ECE/TRANS/WP.29/2009/100  
23 July 2009

Proposal for the 02 series of amendments to Regulation No. 66  
(Strength of superstructure)

Submitted by the Working Party on General Safety Provisions \*/

ARRANGEMENT OF THE APPROVAL MARK

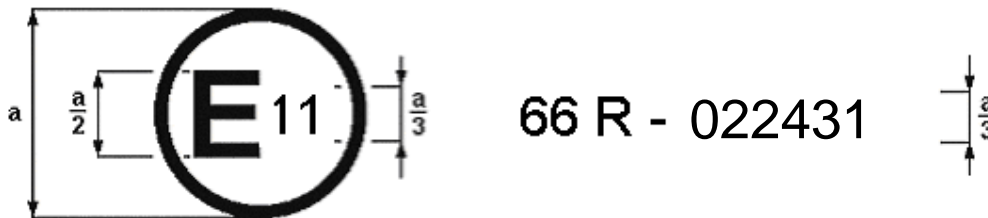
Annex 2., amend to read:

The above approval mark affixed to a vehicle shows that the vehicle type concerned has, with regard to the strength of the superstructure, been approved in the United Kingdom (E11) pursuant to Regulation No. 66 under approval number 022431. The first two digits of the approval number indicate that the approval was granted in accordance with the requirements of the 02 series of amendments to Regulation No. 66."
